1 April 2014

**ADDENDUM #2**

**Addition and Renovations to  
Eastern West Virginia Community & Technical College  
Moorefield, West Virginia**

**RFB 14101**

Item #12 Drawing E703 – Electrical Details

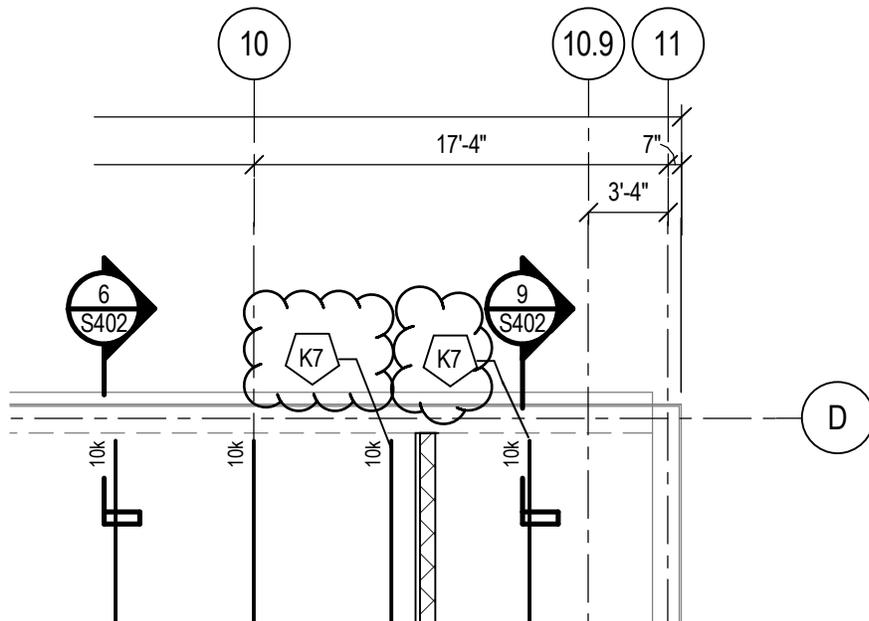
- A. Delete pole base detail for Pole D. Pole D base shall be the same as Poles A and B.

AD2-1

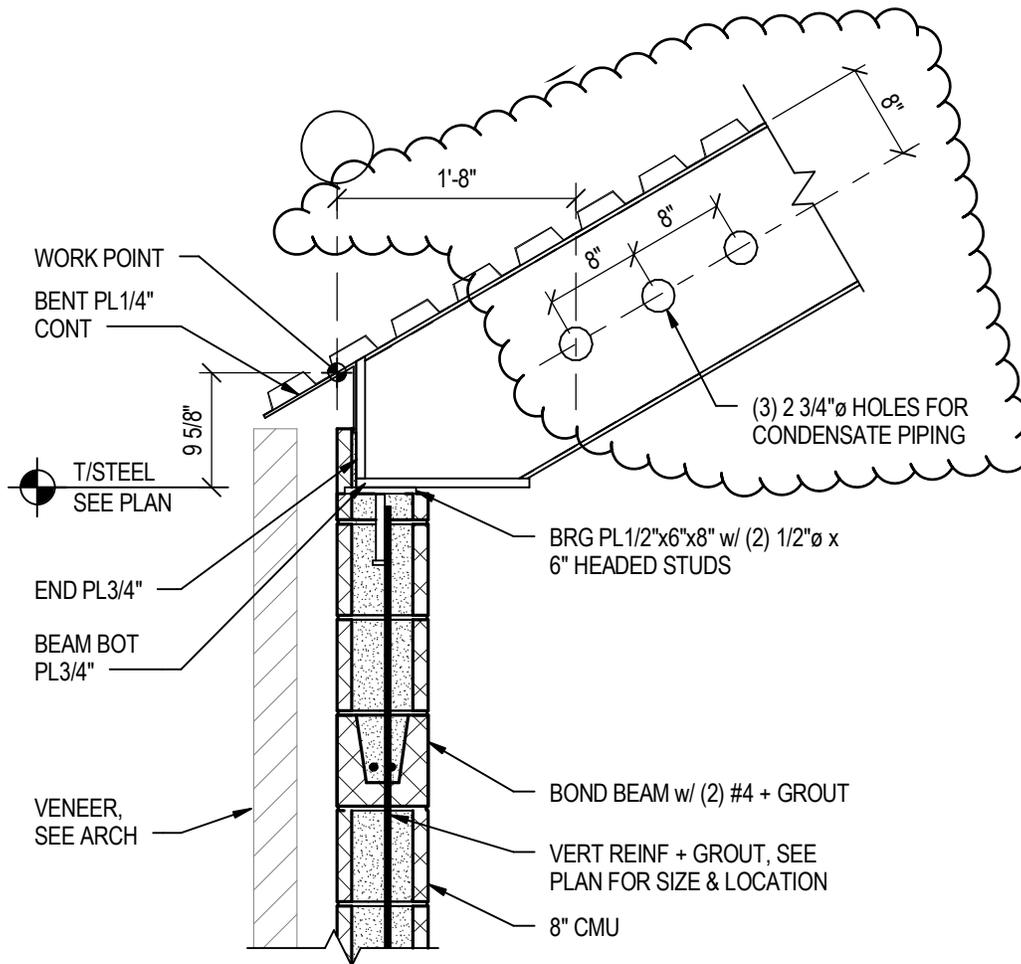
- A. Added Keynote 7. Refer to attached Sketch AD2-1.

1. T/STEEL BEAM EL. SEE PLAN.
2. SEE SHEET S401 FOR METAL DECK SCHEDULE.
3. STEEL FABRICATOR SHALL DESIGN BEAM END CONNECTIONS FOR UNFACTORED LOADS WHERE INDICATED ON PLAN.
4. "A" INDICATES JOIST TOP CHORD AXIAL FORCE DUE TO WIND OR SEISMIC LOADS.
5. DOORS & WINDOWS ARE SHOWN IN APPROXIMATE LOCATIONS, SEE ARCHITECTURAL DRAWINGS FOR EXACT LOCATIONS.
6. SEE SHEET S101 FOR ABBREVIATIONS & LEGEND (SYMBOLS).
7. ADD HOLES FOR CONDENSATE PIPING INTO BEAM PER SECTION 9/S4.2.

AD2-2

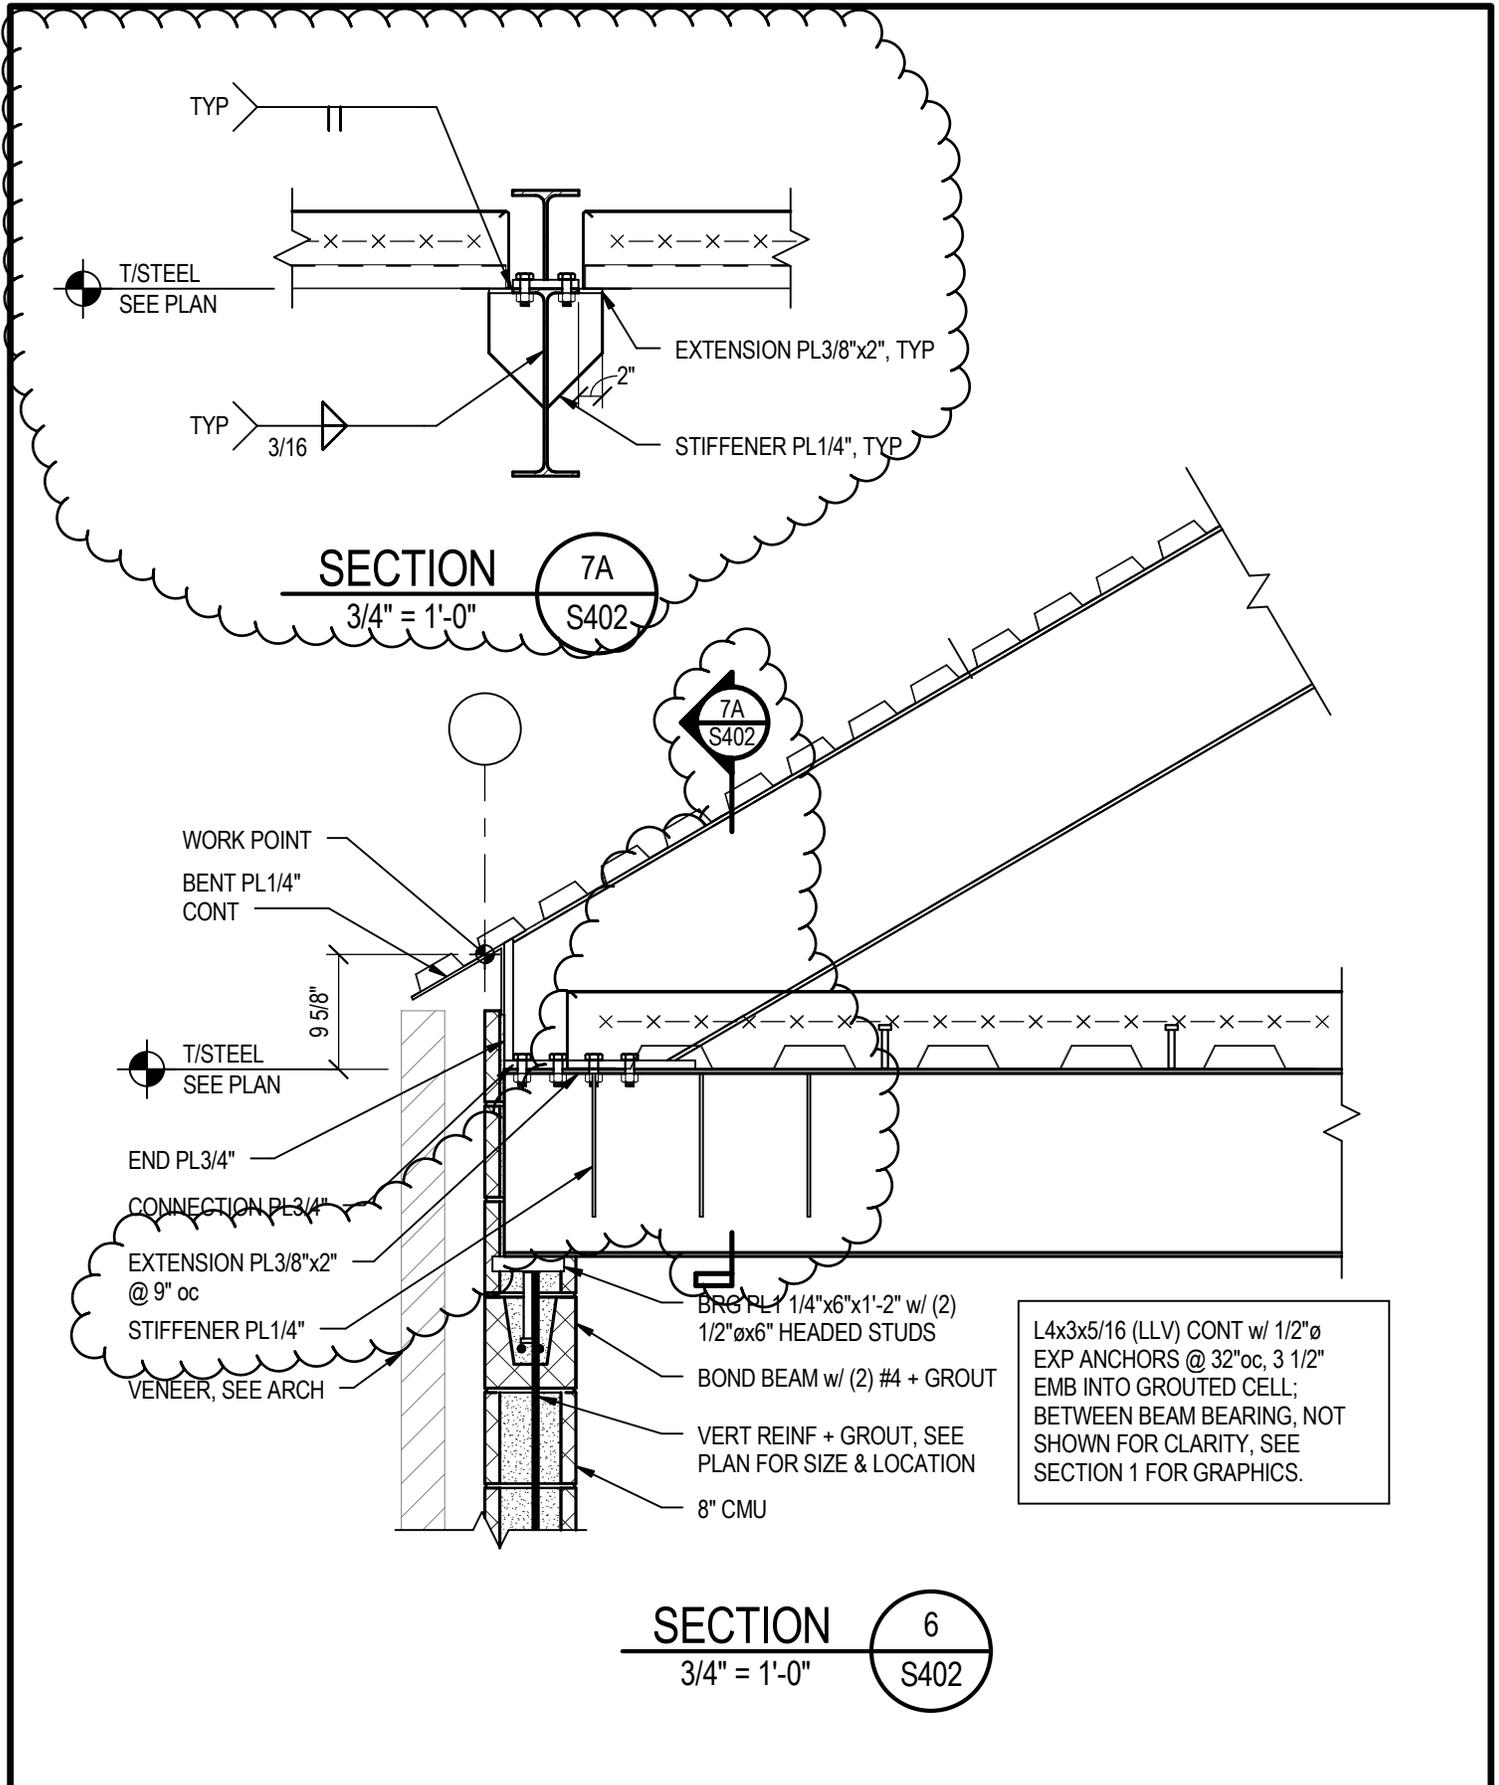
- A. Refer to stair section 2-A501 and revise spacing hole spacing in steel roof beam for condensate piping per attached Sketch AD2-2.

- A. Detail 6 – Added detailing for slab edge and deck bearing at roof/floor beam connection. Refer to attached Sketch AD2-3.
- B. Detail 7 - Added detailing for slab edge and deck bearing at roof/floor beam connection. Refer to attached Sketch AD2-4.
- C. New Detail 7a added to drawing. Refer to attached Sketch AD2-3.
- D. Detail 9 – added holes for condensate piping. Refer to attached Sketch AD2-2.

AD2-E2

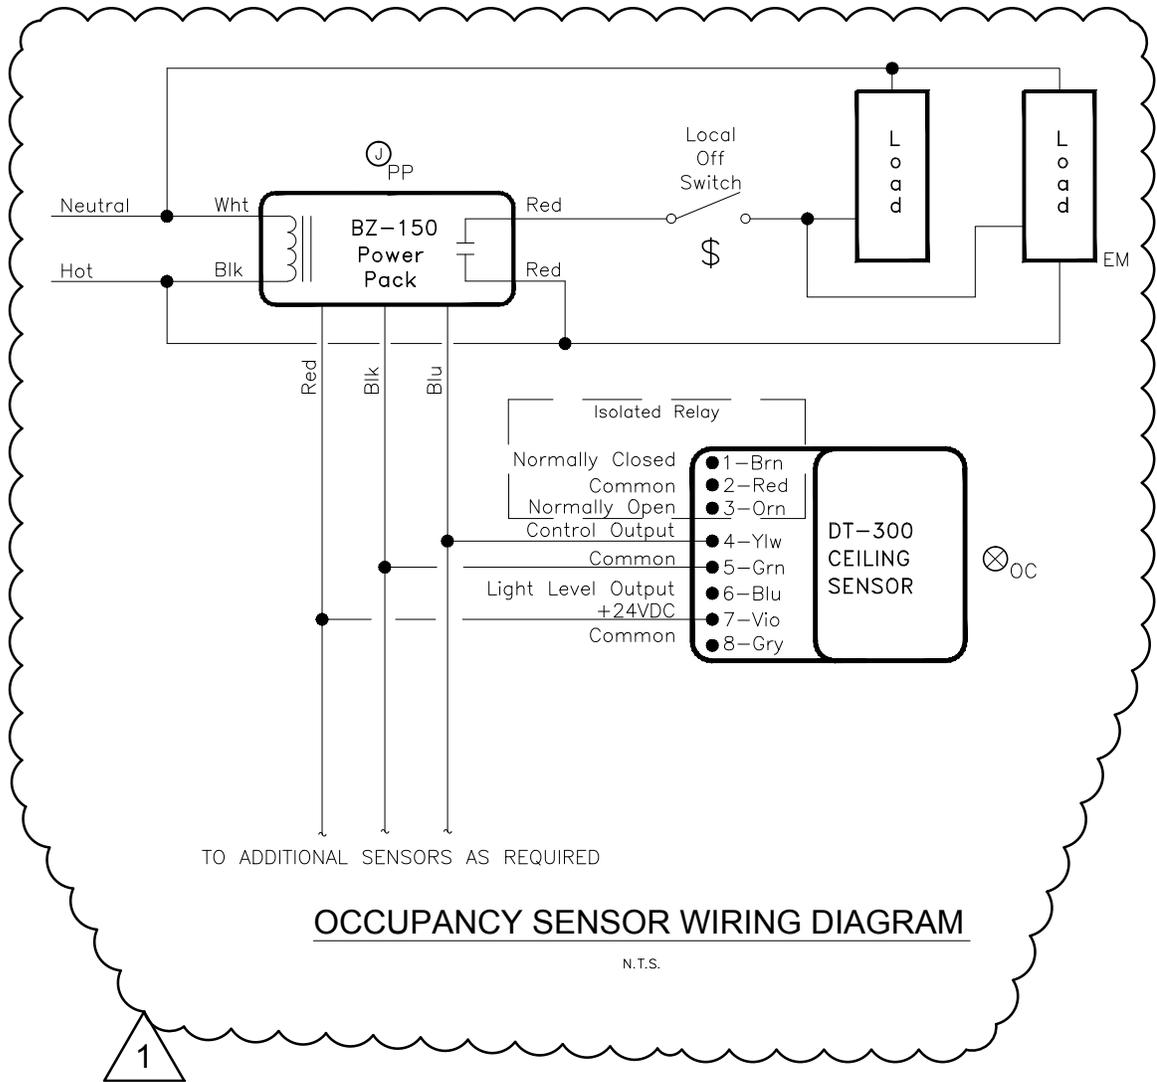
- A. Refer to Sketch AD2-E1.

- 1 WIRING BACK TO JUNCTION BOX TO REMAIN.
2. KEY PAD SECURITY DEVICE TO BE REMOVED, STORED AND RELOCATED TO LOCATION SHOWN ON SYSTEM PLAN. CONDUIT TO BE EXTENDED TO NEW LOCATION. REMOVE CABLING BACK TO SOURCE OR NEXT DEVICE TO REMAIN.
  3. INTERCOM SECURITY DEVICE TO BE REMOVED, STORED AND RELOCATED TO LOCATION SHOWN ON SYSTEM PLAN. CONDUIT TO BE EXTENDED TO NEW LOCATION. REMOVE CABLING BACK TO SOURCE OR NEXT DEVICE TO REMAIN.
  4. CLOSED CIRCUIT TELEVISION DEVICE TO BE REMOVED, STORED AND RELOCATED TO LOCATION SHOWN ON SYSTEM PLAN. CONDUIT TO BE EXTENDED TO NEW LOCATION. REMOVE CABLING BACK TO SOURCE OR NEXT DEVICE TO REMAIN.
  5. EXISTING SMOKE DETECTOR TO REMAIN. MAINTAIN AND

- 1 2A. EXISTING VAV BOX TO REMAIN.
- 3A. LIGHTING FIXTURE TO BE REMOVED. REMOVE CONDUIT AND WIRING BACK TO JUNCTION BOX TO REMAIN.
  - 4A. CLOSED CIRCUIT TELEVISION DEVICE TO BE REMOVED, STORED AND RELOCATED TO LOCATION SHOWN ON SYSTEM PLAN. CONDUIT TO BE EXTENDED TO NEW LOCATION. REMOVE CABLING BACK TO SOURCE OR NEXT DEVICE TO REMAIN.
